Response to Public Comment and Mitigation Plan Peer Review Comments

Critical Area Determinations: CAO17-0008 & CAO17-009
8375 & 8379 E Mercer Way – Mercer Island, Washington

Figure 1 – Mercer Island GIS Map Showing Stream Gradients

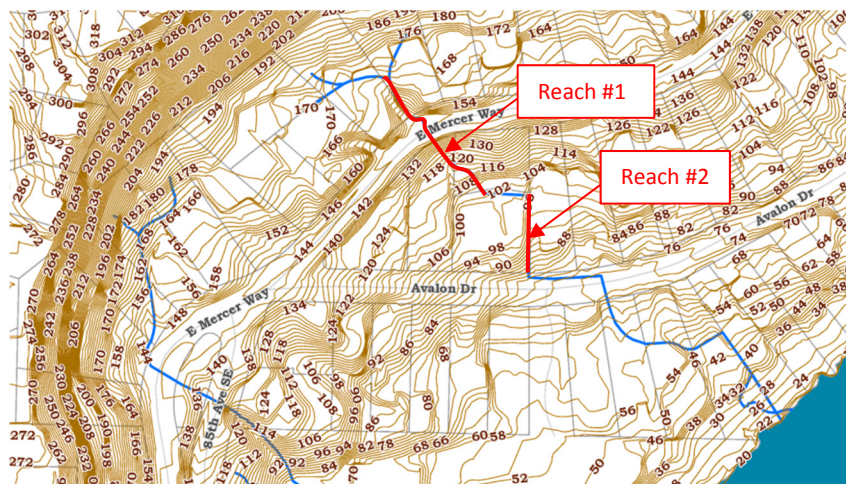
1. Karen Walter - Muckleshoot Indian Tribe Fisheries Division (September 13, 2017 @ 2:59:07PM)
 1. Additional data regarding stream gradient.

Response: Total stream length is approximately 1,250 feet. There are two stream reaches that exceed a 20% gradient for a total of 253 feet, or 28% of total stream length. Figure 1 shows the location, length, and average gradient for the stream reaches used to determine the watercourse as non-fish bearing. The non-fish bearing determination is consistent with prior City of Mercer Island critical area mapping and supported by recent determinations made regarding the project by City of Mercer Island peer review consultants.

Reach #1
283 feet @ 21%

Reach #2
70 feet @ 28%

Figure 2 – Location of Wetland Seeps within Wetland A

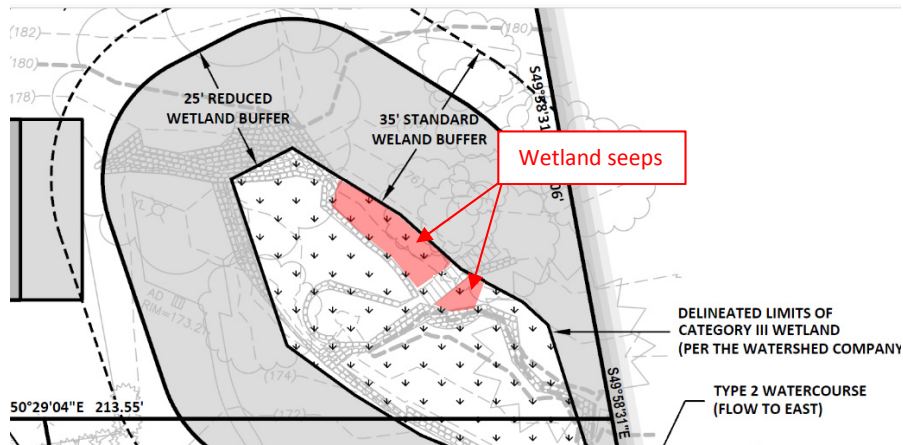
- a) Location of seeps within Wetland A.

Response: *Wetland seeps are located on the north side of Wetland A between the permanent pond and the delineated wetland limits. Figure 2 shows the location of seeps within Wetland A.*
